SERVICE LETTER

STANDARDIZATION OF THE CRANKSHAFT/PISTON PIN AND OF THE GEARBOX FOR ROTAX® ENGINE TYPE 912/914 (SERIES)

SL-912-002 R2

SL-914-002 R2

Bild / Fig. 2
03225

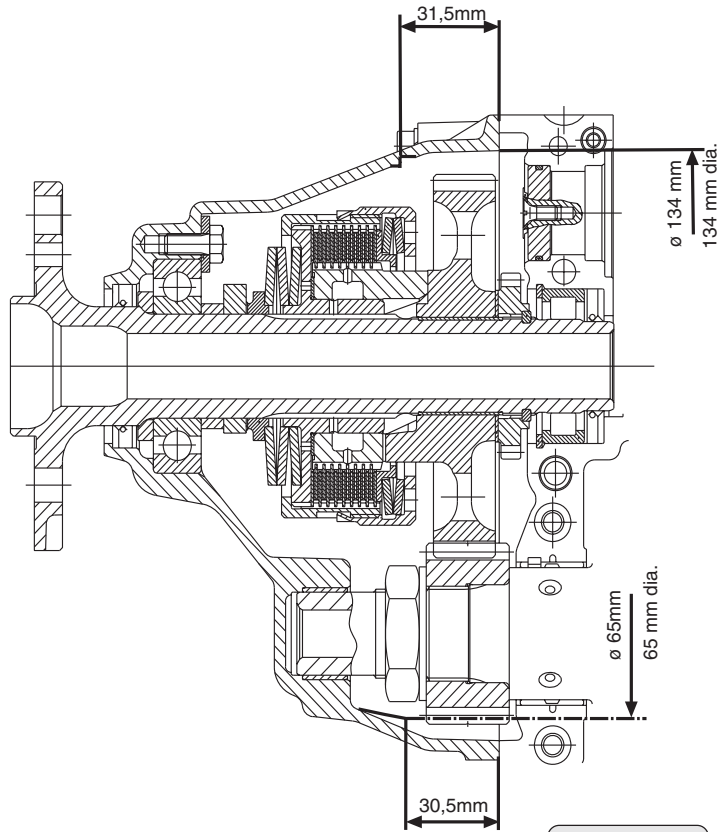
The changed axial position of the drive gear and the dog gear of increased width require extra space in the gearbox housing (see fig. 2).

■ **CAUTION:** The crankshaft part no. 888164 is allowed to be installed only in the gearbox housing part no. 911746, where the space between gear set and housing wall will be ensured.

für breiten Zahnradsatz
for wide gear set

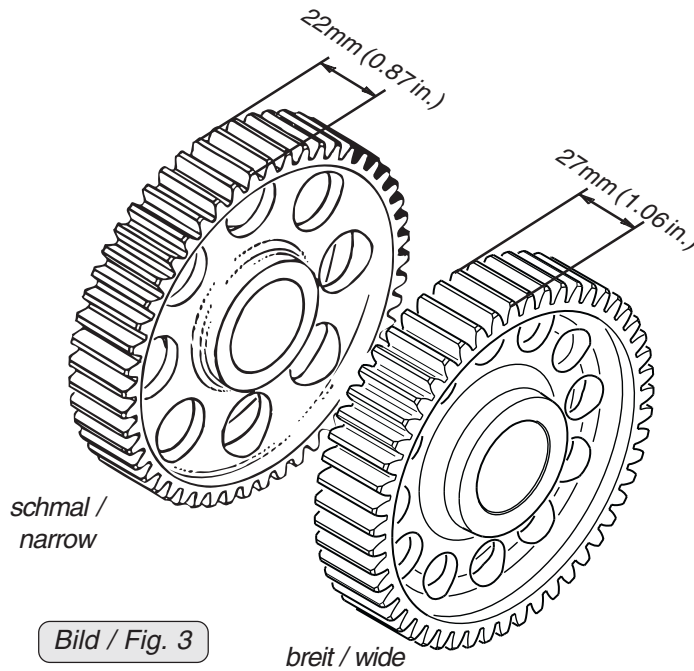
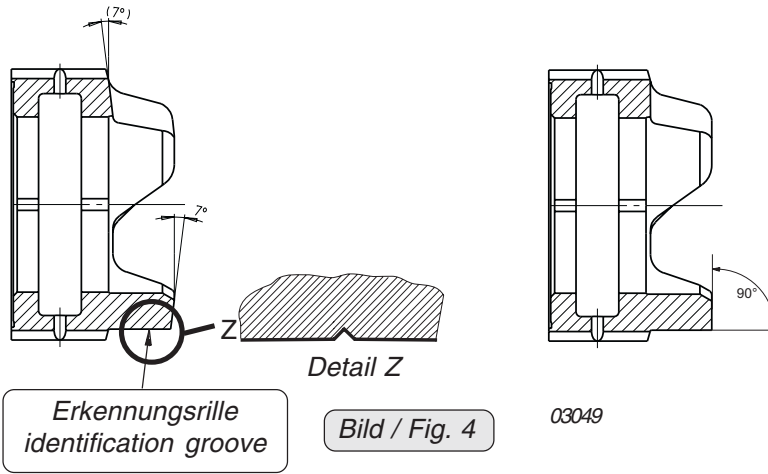
The increase in dog gear width made modification of the dog support surface necessary. The dog support surface is now machined 7° tapered (see fig. 4).

▲ **WARNING:** A gear set of the increased width must be only paired with the **7° tapered dog hub** part no. 958892 (without overload clutch) and is allowed to be fitted only together with the overload clutch of new design part no. 996887.

This new dog hub and new dog gear of the overload clutch must never be used in connection with a gear set of narrow width as the contact surfaces do not match correctly.

◆ **NOTE:** The new dog hub and dog gear of the overload clutch and the dog gear of increased width can be identified by a groove (see fig. 4).

crankshaft, part no.996583 or before: <1mm
crankshaft, part no.888164: 5 - 7 mm

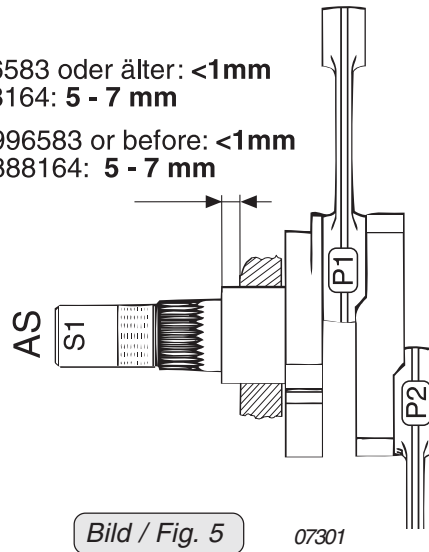
Because of the wider dog gear, it became necessary to change the axial position of the drive gear. Therefore the crankshaft part no. 888164 is furnished with a longer ending (see fig. 5).

▲ **WARNING:** If the modified crankshaft part no. 888164 will be installed instead of the previous one (part no. 996583) take care of the following:

Bild / Fig. 6

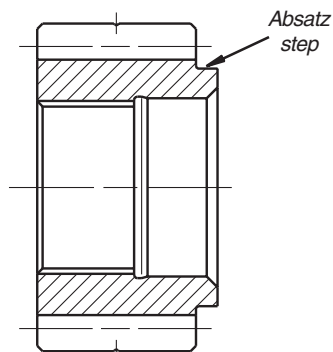
This gear set is necessary if a gearbox with a narrow gear set has to be converted into a gearbox with an increased gear set width and for a crankshaft part no. 996583 or older.

- ◆ **NOTE:** This gear set is with a drive gear of increased width which compensates for the axial staggering between crankshaft part no. 996583 and dog gear of increased width.
- ◆ **NOTE:** The interim gear set is only available with reduction ratio 2,43.
- ▲ **WARNING:** This gear set is allowed to be installed only together with a crankshaft part no. 996583 or of earlier date and in gearbox housing part no. 911746.

Bild / Fig. 7

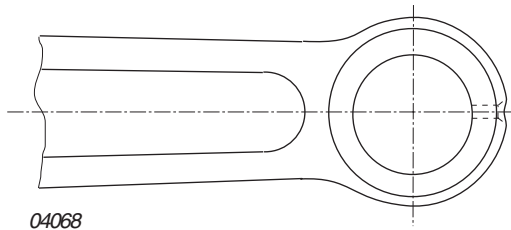
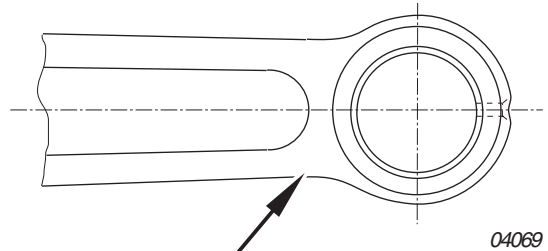
▲ **WARNING:** At the crankshaft part no. 888164 must only be used the piston pin part no. 916356. (see fig. 7-10)

All these engines the piston pin part no. 916356 can be install without considering the serial number.

■ **CAUTION:** For reason of weight limits there must be only 4 same piston pin installed in one engine. To prevent any mix-up, see the illustration fig. 7 to 10.

Bild / Fig. 8

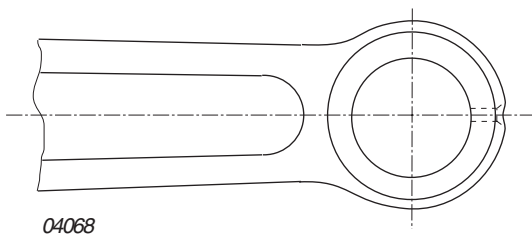
ersetzt durch/ replaced by

TNr./ part no. 916356
Gewicht/ weight ~ 85g

Bild / Fig. 10

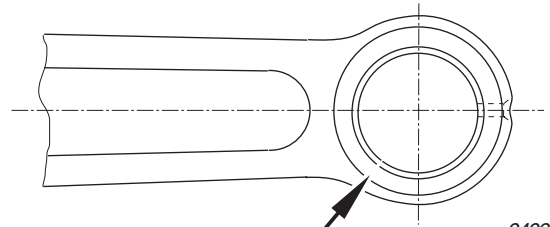
- In using of the crankshaft part no. **996583 without conrod bushing** (engines **previous** „group A“), there must be only 4 nitride piston pin part no. 916420 (black surface) installed. (see fig. 10)
- In using of the crankshaft part no. **996583 with conrod bushing** there must be only 4 piston pin part no. 916356 installed.
- In using of the crankshaft part no. **888164** (engines **previous** „group A“) there must be only 4 piston pin part no. 916356 installed.
